## PIC16C620A Rev. A Silicon Errata Sheet

The PIC16C620A (Rev. A) parts you have received conform functionally to the Device Data Sheet (DS30235G), except for the anomalies described below.

**FIGURE 1:  $\overline{\text{MCLR}}$  EXTERNAL CIRCUIT**

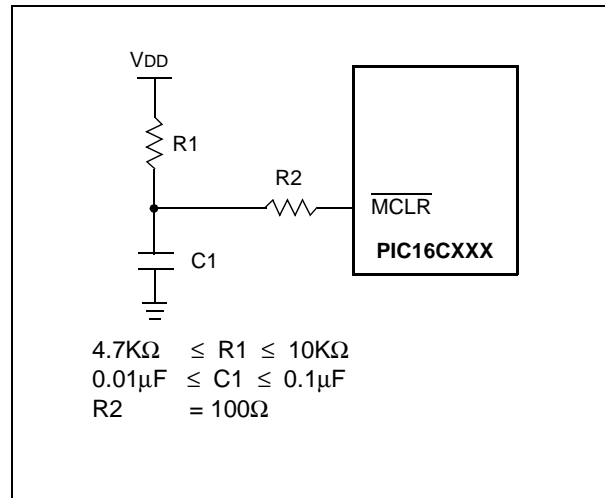
The minimum specification for the  $\overline{\text{MCLR}}$  must be met in order to RESET the PIC16CXXX. If a  $\overline{\text{MCLR}}$  pulse occurs that is less than the minimum specification (parameter #30), improper device operation can occur.

If the Minimum specification cannot be met, then an external circuit must be used to insure that any pulse width less than the specification will be filtered before it reaches the  $\overline{\text{MCLR}}$  pin.

A possible circuit is shown in Figure 1. Proper design validation needs to be done to ensure desired operation over the applications operating conditions

**Figure 1: Wake-up from Sleep**

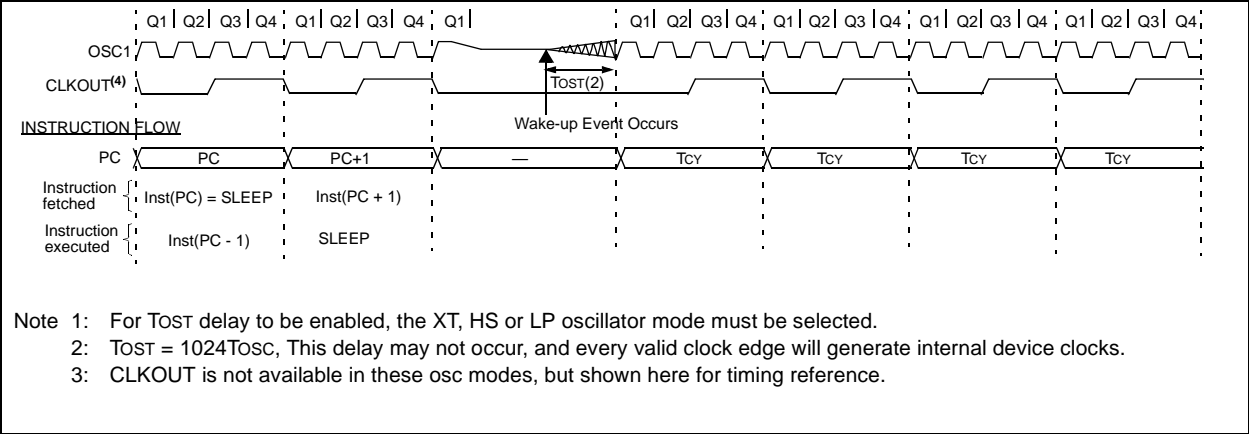
The Oscillator Start-up Timer (TOST) delay may not occur when the device wakes-up from sleep.

Figure 1 shows the start-up of the crystal after the event that causes the device to wake up from sleep mode (as specified in device data sheet). The start-up time (TOST) may not occur.

After the SLEEP instruction, do a software delay of 256 TcY (same as 1024 TOSC). At the Reset and Interrupt vector addresses, test to see if the device woke from sleep (the  $\overline{\text{TO}}$  and  $\overline{\text{PD}}$  bits), and if the device did wake from sleep, ensure that the total cycle delay is 256 TcY.
